TURKEY POINT PLANT UNIT NO. 3

AMENDMENT TO FACILITY OPERATING LICENSE

Amendment No. 203  
License No. DPR-31

ATTACHMENT TO LICENSE AMENDMENT

FIGURE 3.1-2

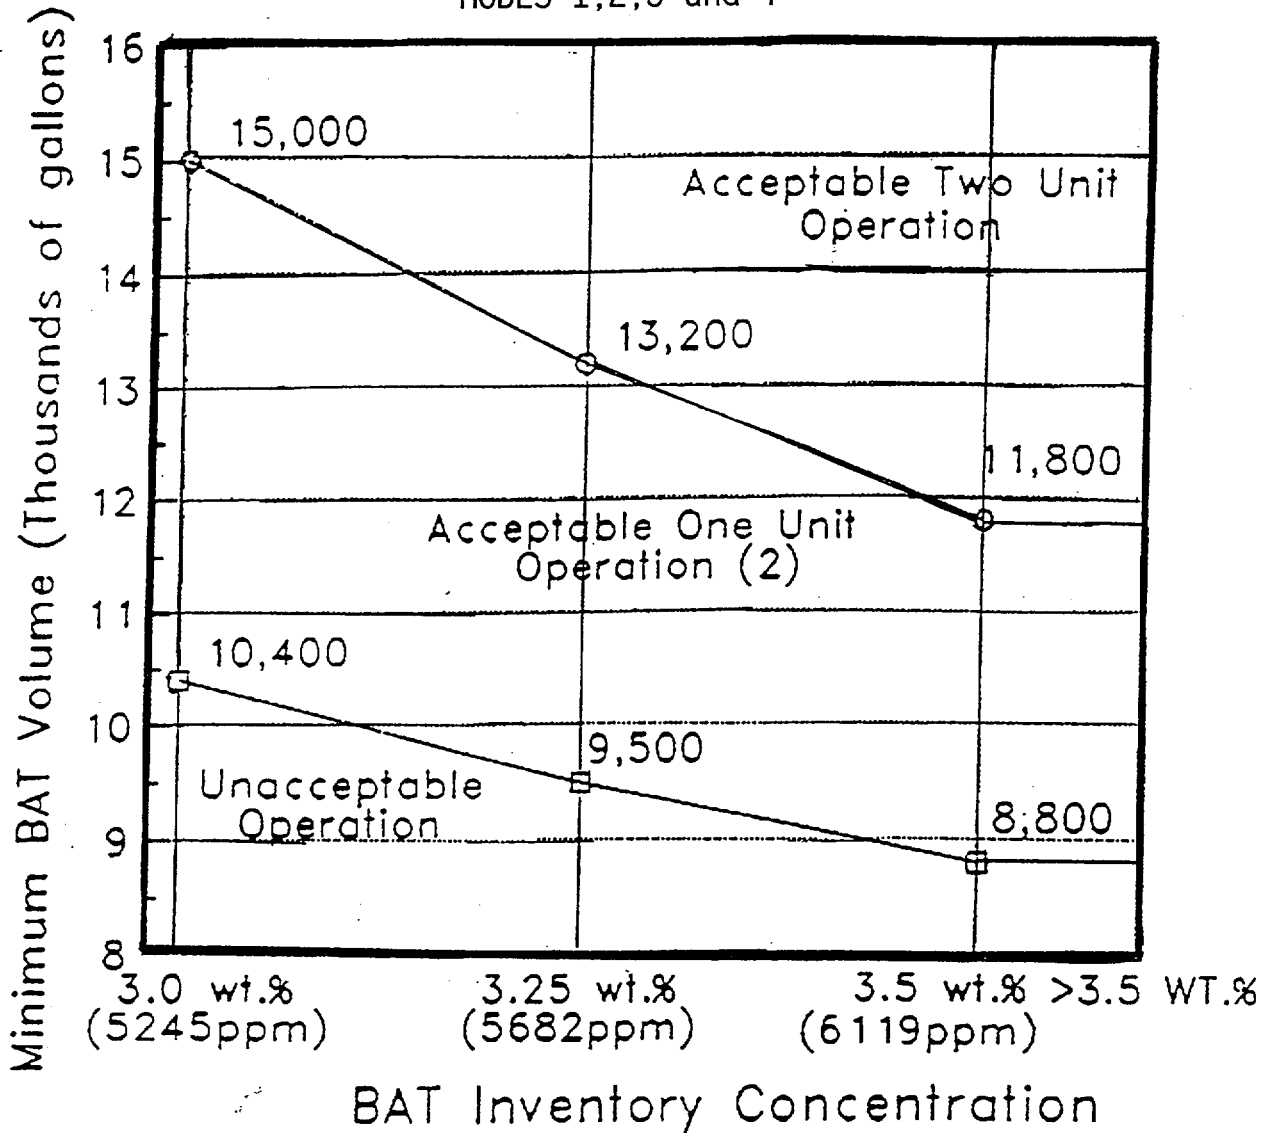
- a. A Boric Acid Storage System with:
  - 1) A minimum indicated borated water volume in accordance with Figure 3.1-2,
  - 2) A boron concentration in accordance with Figure 3.1-2, and
  - 3) A minimum boric acid tanks room temperature of 55°F.
- b. The refueling water storage tank (RWST) with:
  - 1) A minimum indicated borated water volume of 320,000 gallons,
  - 2) A minimum boron concentration of 1950 ppm,
  - 3) A minimum solution temperature of 39°F, and
  - 4) A maximum solution temperature of 100°F.
